## APPLICATION FOR APPROVAL OF CONSTRUCTION CHANGE DOCUMENT – CCD CATEGORY A/B

Balboa Elementary School  
1844 Bel Aire Drive, Glendale, CA 91201

03-31-17 CCDA-035

**A1.11**

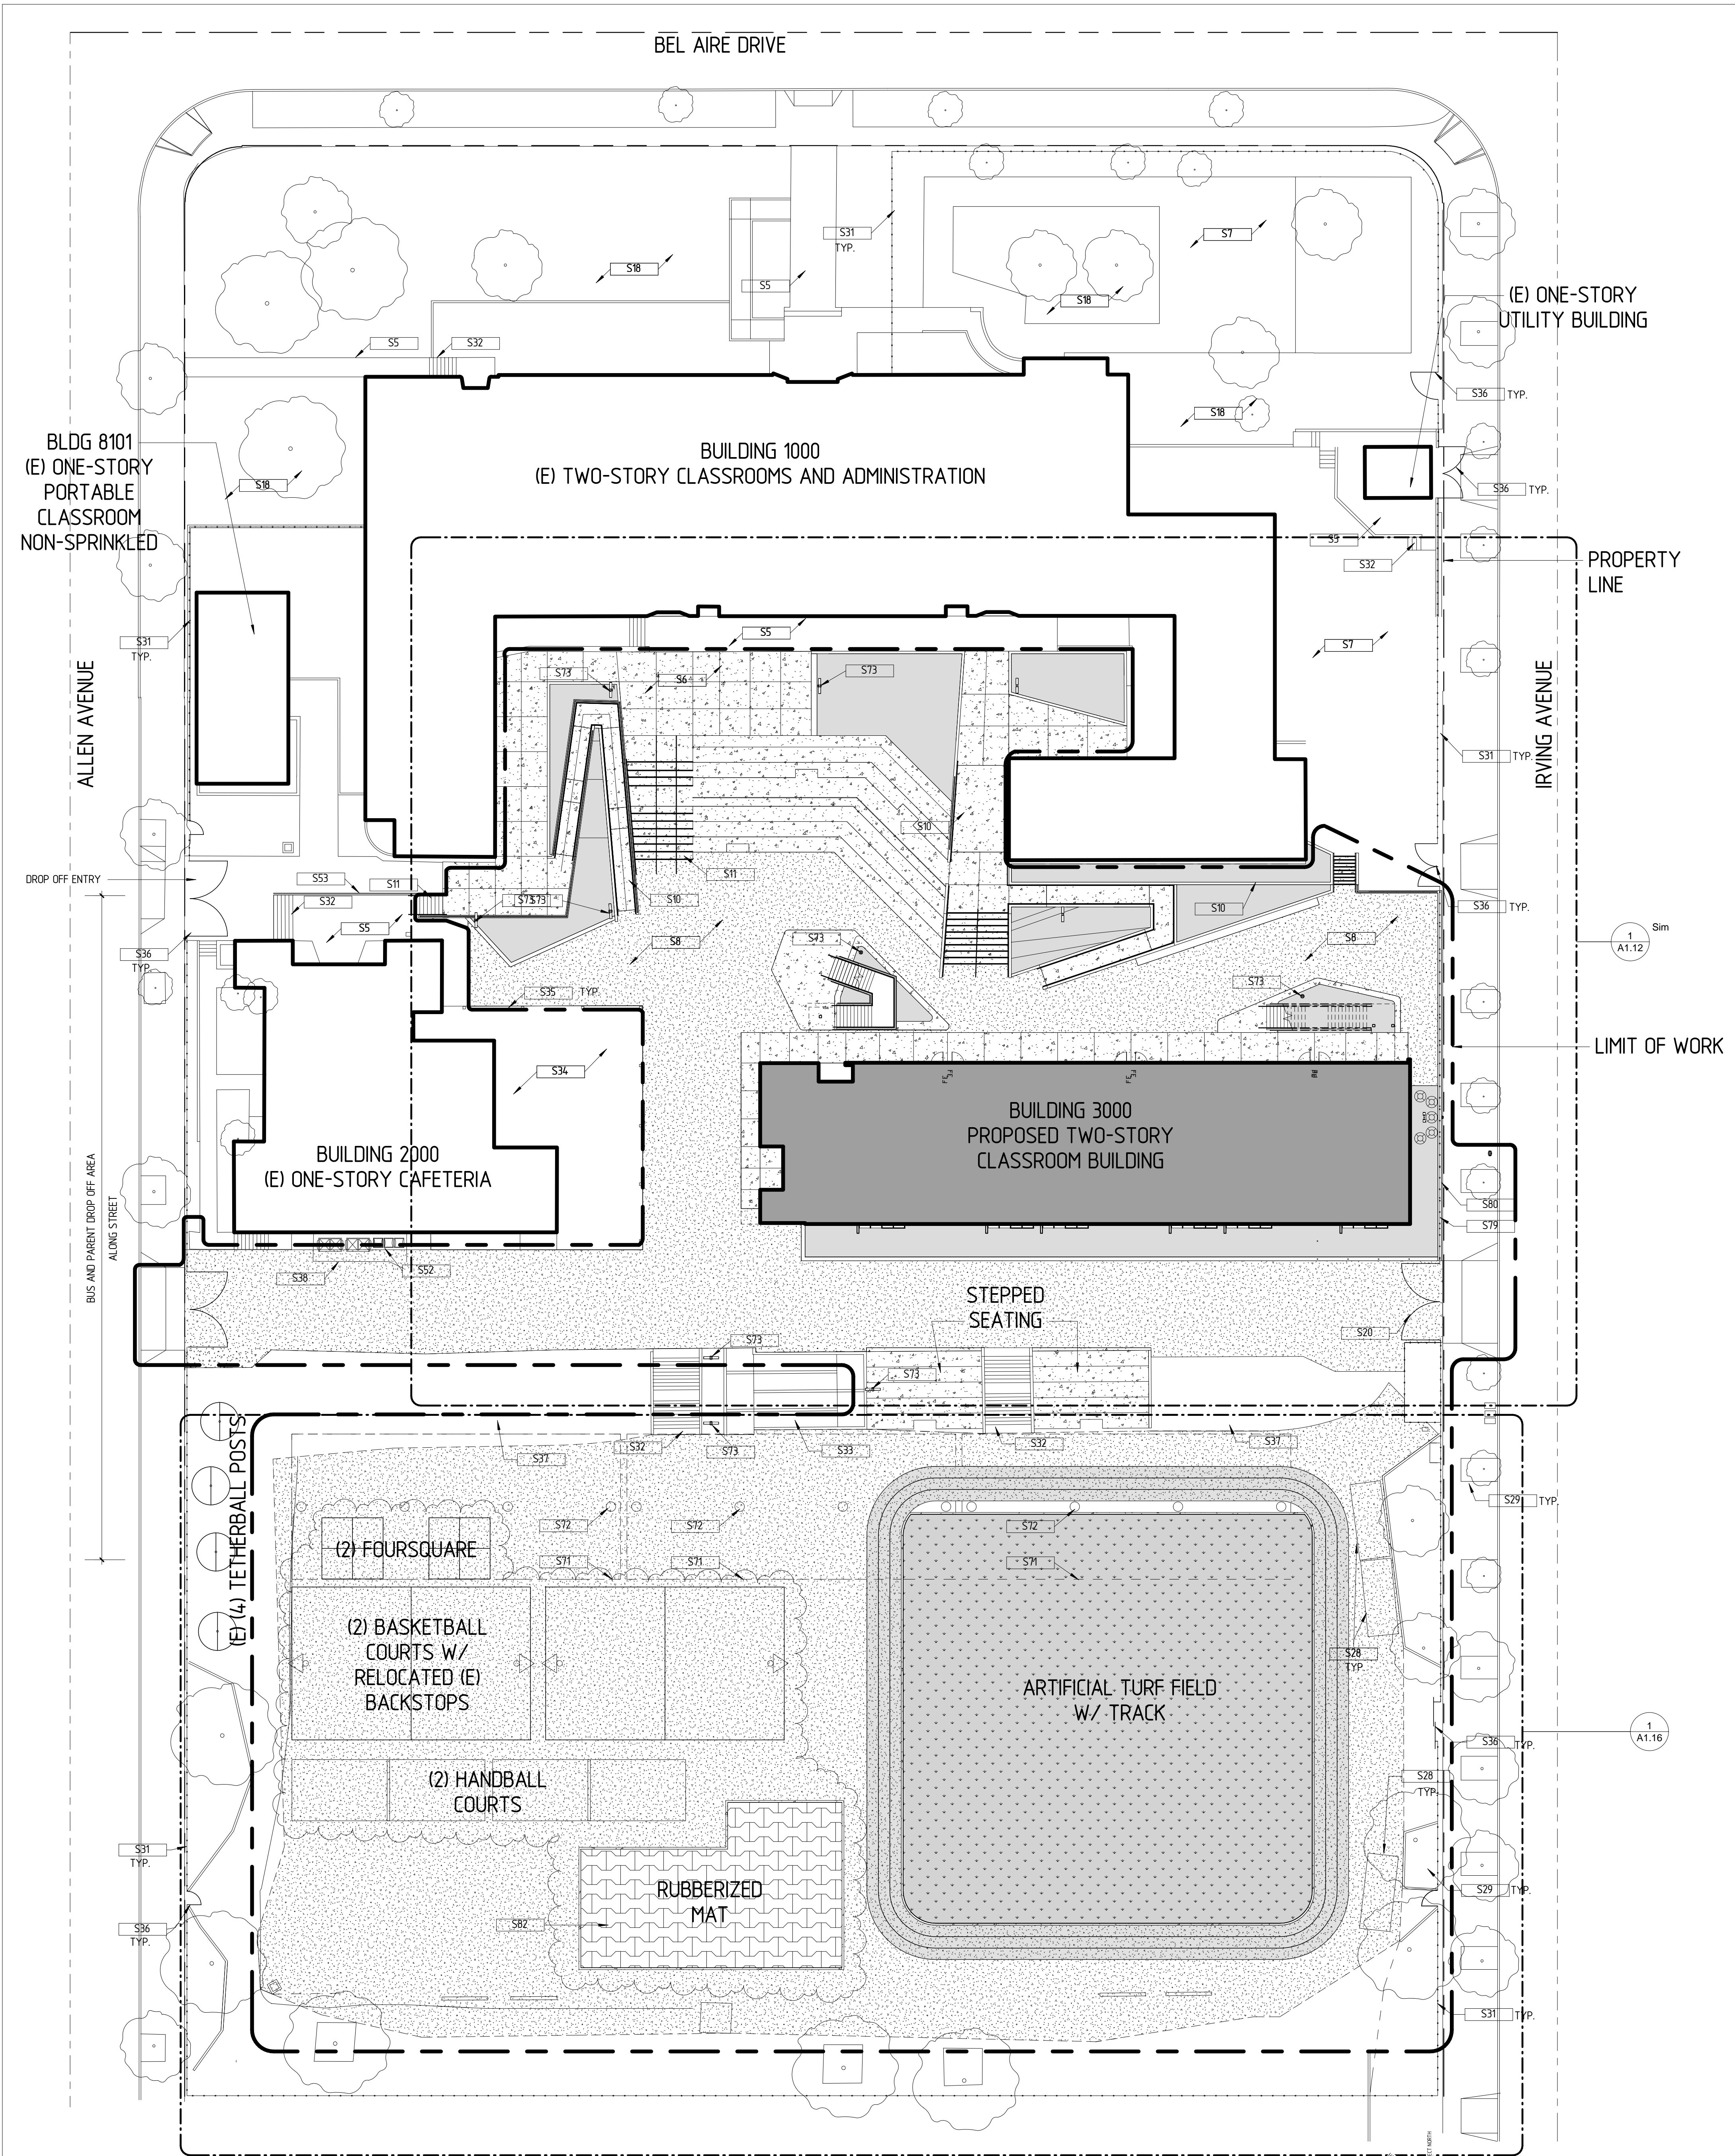
| KEY | TEXT                                     | KEY | TEXT   |
|-----|--|-----|--|
| S31 | (E) CHAIN LINK FENCE                     | S82 | PLAYGROUND OVERHEADS TO BE INSTALLED AT HEIGHTS SPECIFIED BY DISTRICT  |

**<AS REVISED>**

A1.16

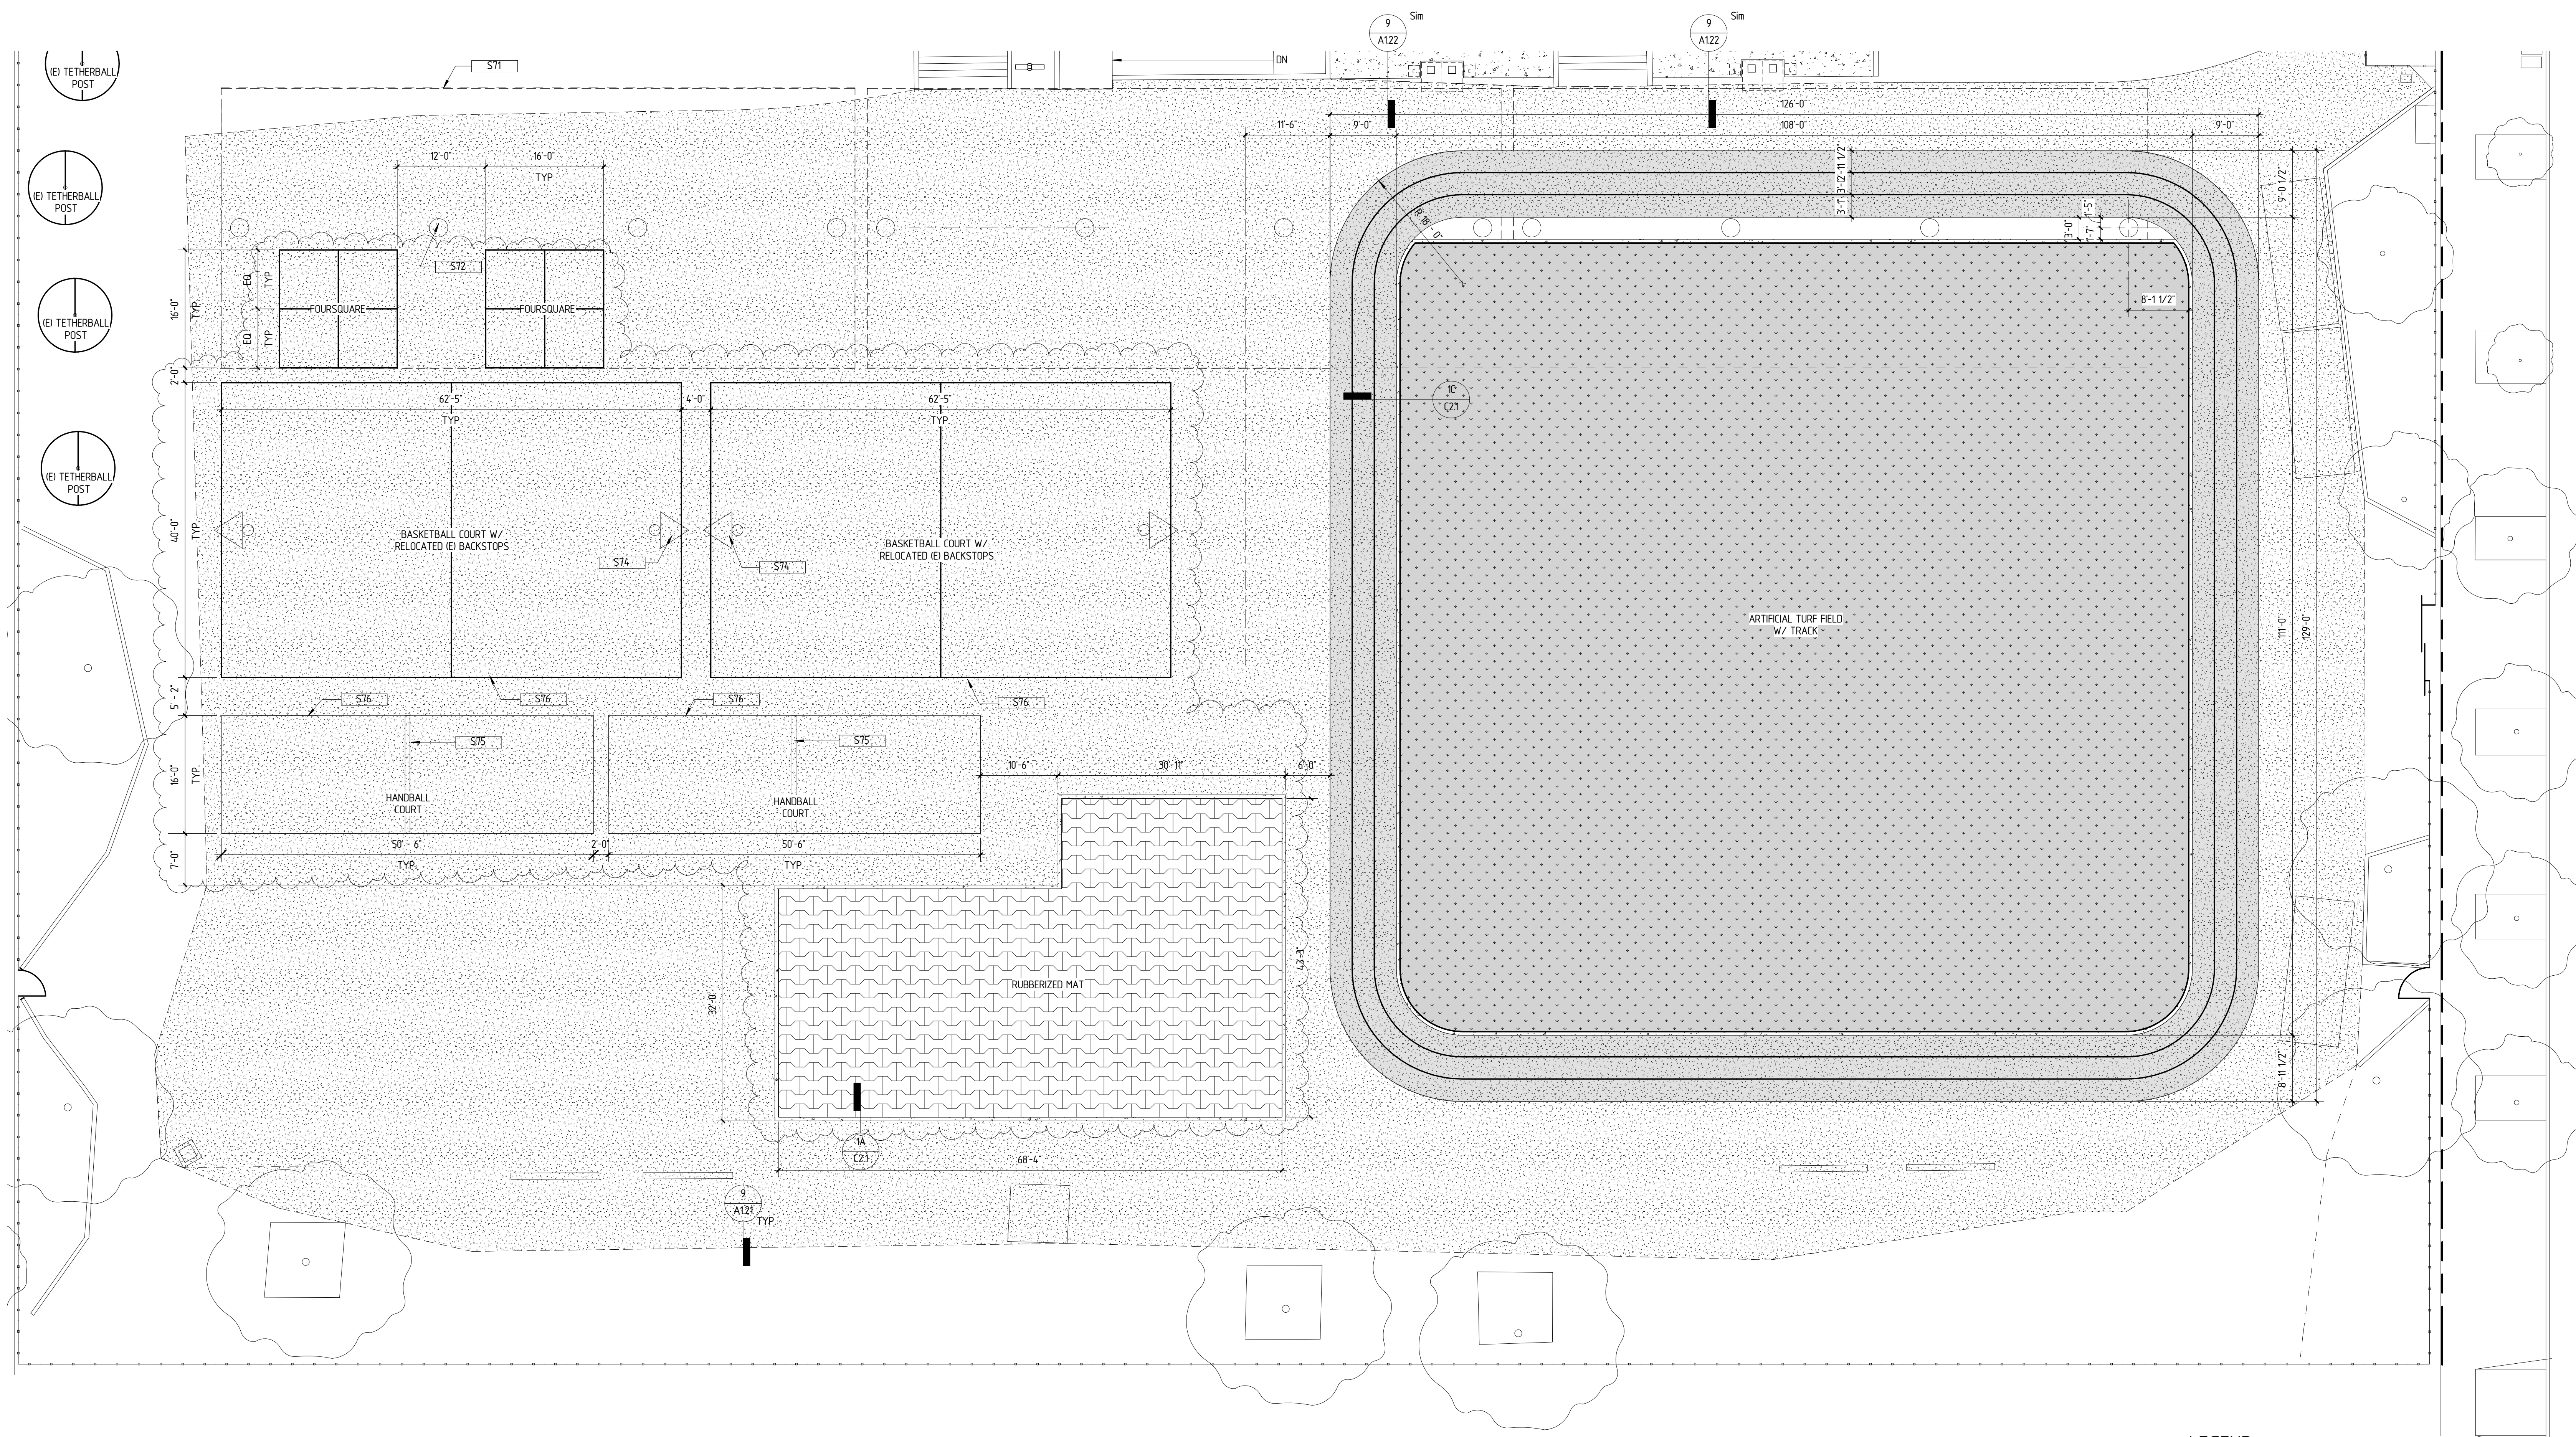
<AS REVISED>
